Federal Aviation Administration

Memorandum

Subject: Equivalent Level of Safety to § 23.1091(b)(4);
Flight Crew Override Means for Automatic Alternate Air Door in Cirrus Design
SR22 with Engine Technologies, Inc. Turbo Normalizer STC, ACE-06-06

Figure 1 - Alternate Air Door (closed)

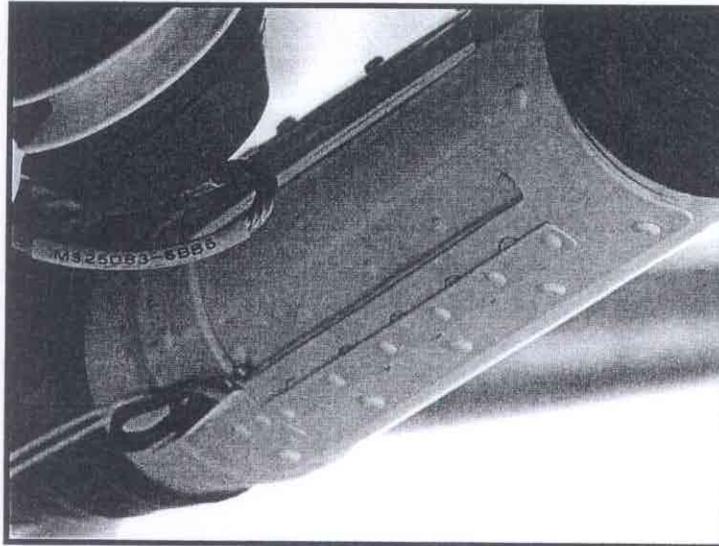
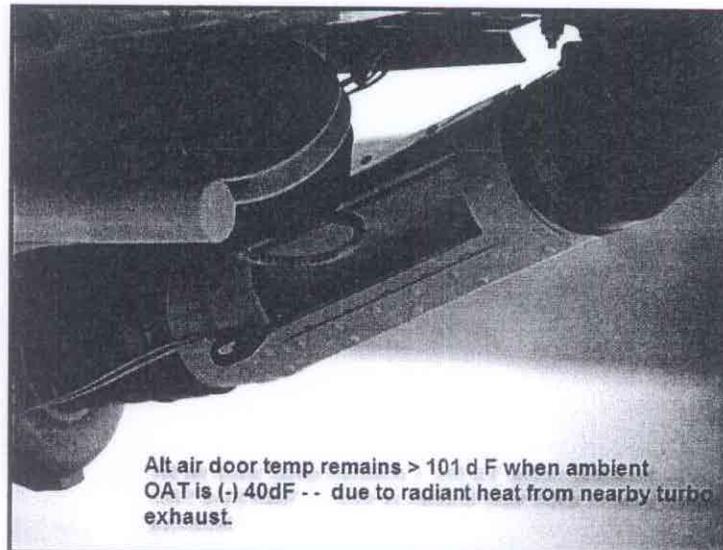
Engine Technologies, Inc. intentionally placed the automatic alternate air door featured by their turbo normalizing design under the engine near the exhaust. This maintains the temperature of the air door high enough that it is not possible for the air doors to freeze shut, even under the most extreme cold weather conditions. The design uses magnets to hold the alternate air door closed until the difference in air pressure on either side of the door is great enough to open it. The alternate air door is shaped to ensure that the air flowing to the turbochargers forces the door completely open. There are no springs on the air door. The magnets provide the only force to overcome when opening the air door. The alternate air door system is automatic. A microswitch on the door activates an indicator on the MFD in the cockpit to indicate when the door is open.

We concur that the automatic alternate air door design used by Engine Technologies, Inc provides an equivalent level of safety to the requirements of 14 CFR, part 23, § 23.1091(b)(4).
